Progress Energy

Levy Nuclear Plant Units 1 & 2 Responses to RAI Comments on Cross Florida Barge Canal Recreational Access Permit

FDEP File Number
38-272432-002-ES

September 2008

ACCESS ROAD BYPASS CHANNEL BRIDGE PLAN AND ELEVATION

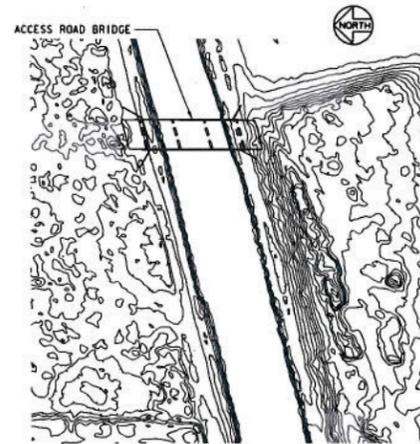
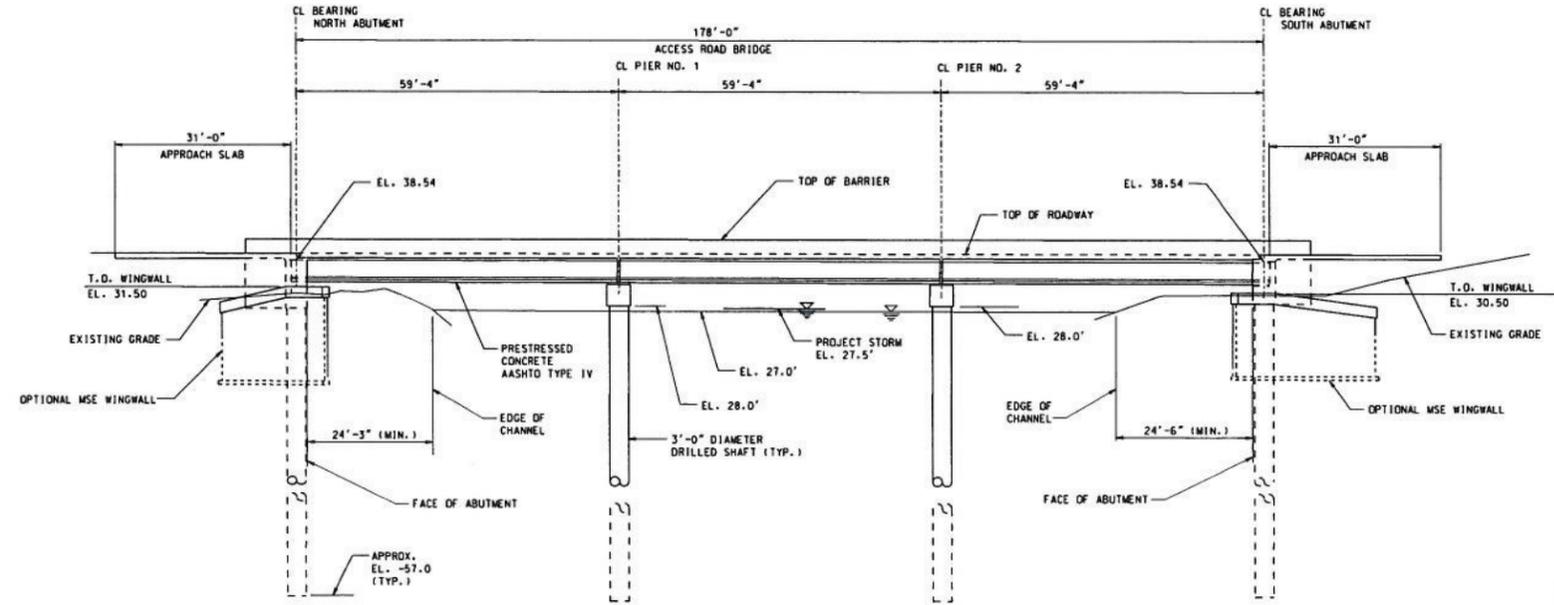
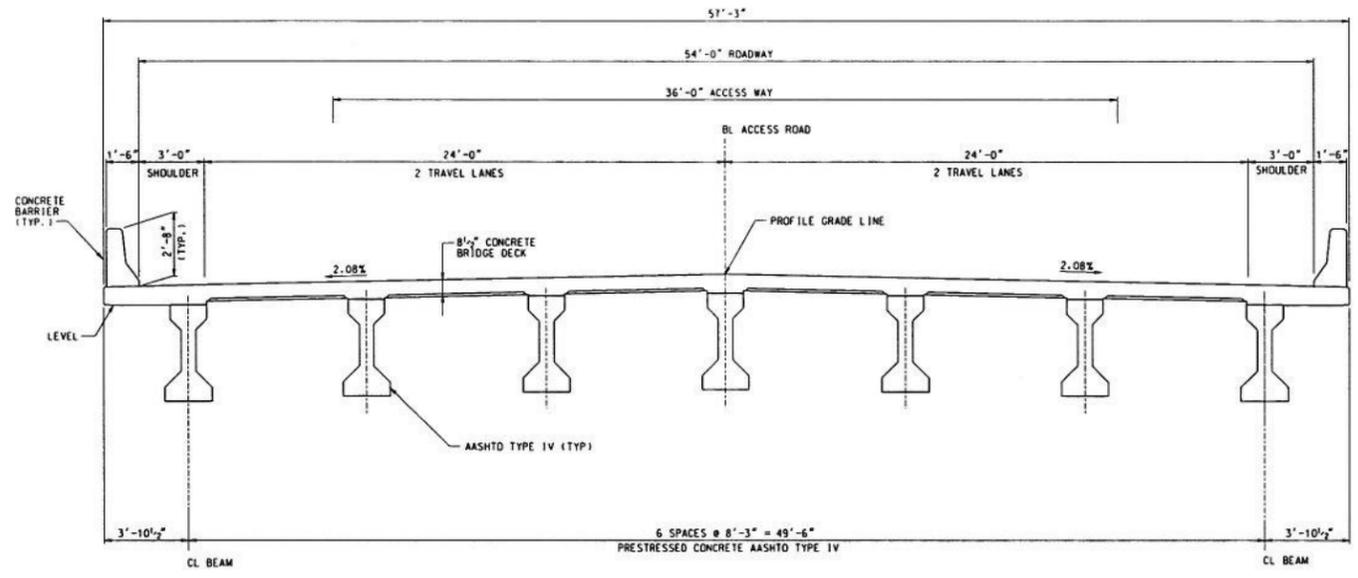
The proposed project will require a public easement to cross state-owned submerged lands. Please submit the attached Public Easement package with all of the required information.

3. A scaled and fully dimensioned drawing showing the proposed bridge over the Inglis Lock Bypass Channel was included in the original application. Drawing LNG-X001-C2-001 and Drawing LNG-X001-C2-003 follow this response and show the proposed bridge in plan view and cross-sectional view, respectively.

IMPACT OF
 DEVELOPED AREAS ON WETLAND

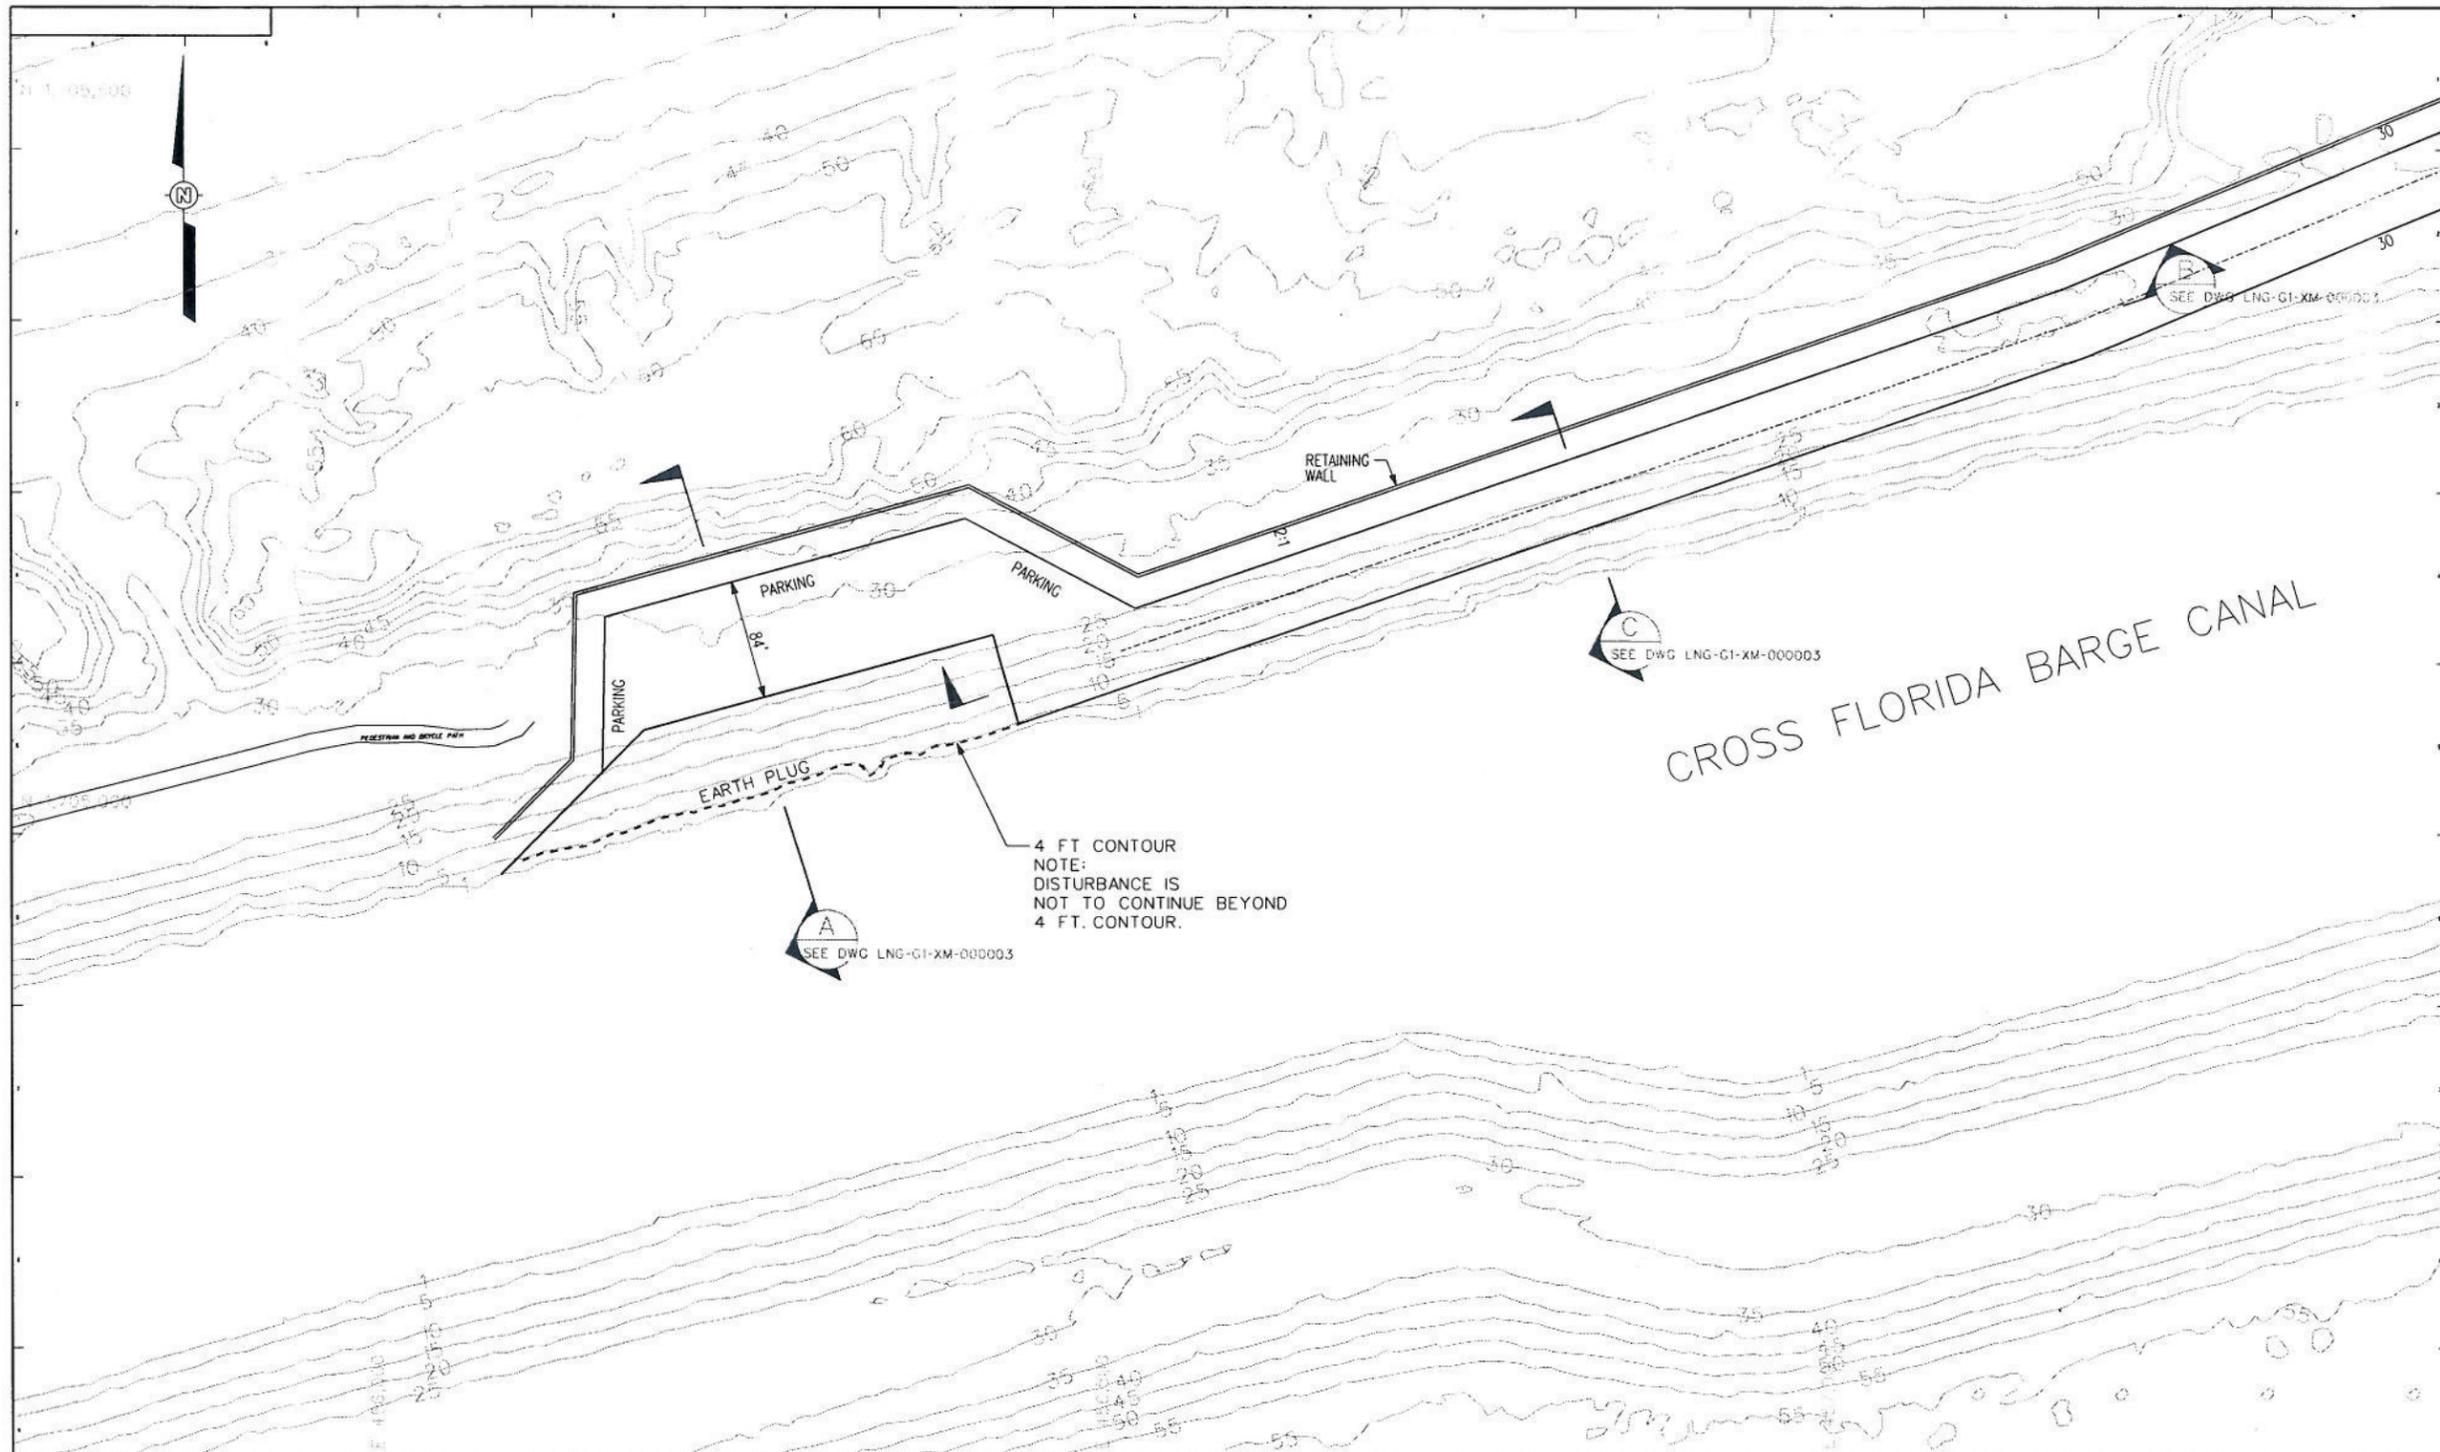
1. No site plan drawings were provided with the application materials. Please provide a site plan that depicts the exact location and gives measurements for all elements of the proposed construction: the bridge, the excavation area, the boat ramp and the barge slip.

1. A dredge/fill site plan, Drawing LNG-G1P1-X3-002, Impact of Developed Areas on Wetland, is included with this response. The following descriptions provide additional detail for the bridge, excavation area, and barge slip.

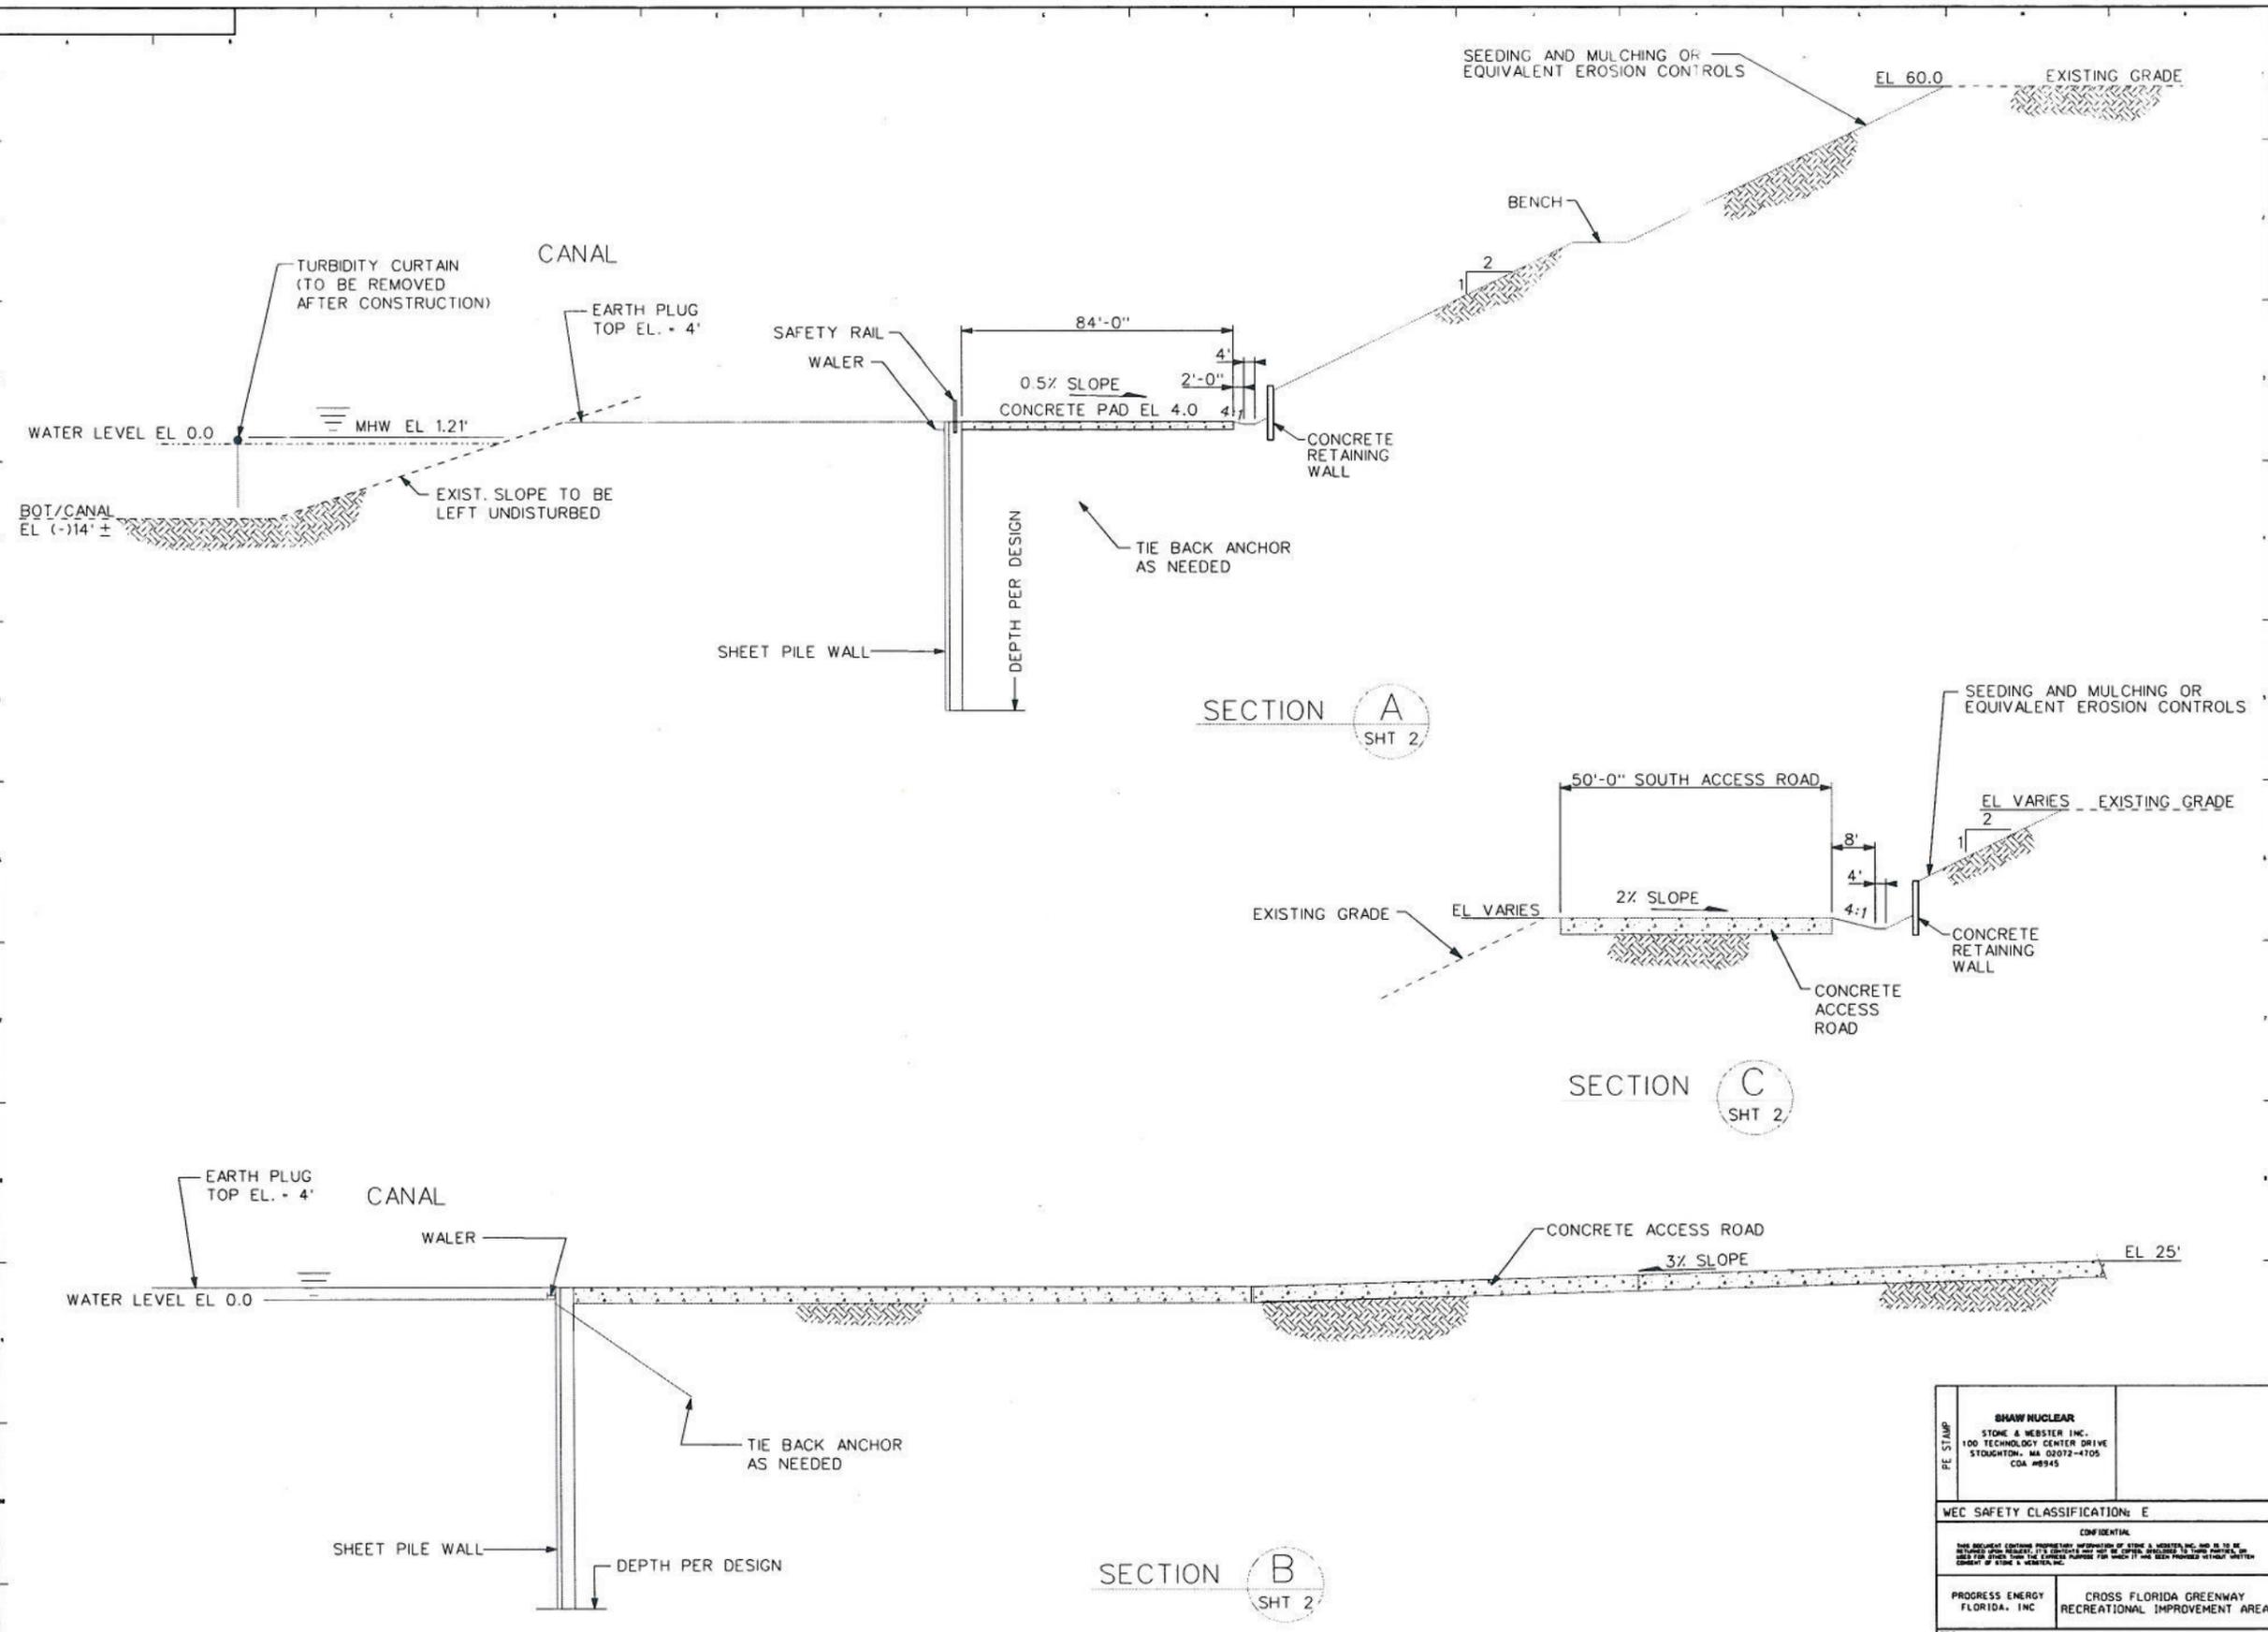
5. Please provide additional information about the proposed excavation and dredging mentioned in the application materials. What is the purpose of the excavation and dredging? What method of dredging is proposed?

- Excavation Area: The excavation area is above the mean high water line, as shown in Drawing LNG-G1-XM-000002, Boat Slip General Arrangement Plan, and Drawing LNG-G1XCM-000003, Boat Slip Sections, which follow this response.

5. No dredging is proposed under this permit application. The excavation is to support the early site work necessary to create a barge slip to support the construction of the

- Levy Nuclear Plant. Excavation will be limited to areas that are upland of the mean high water. During construction activities, a berm will be maintained between the site work and the Cross Florida Barge Canal and a turbidity curtain within the Cross Florida Barge Canal will be maintained to protect water quality.
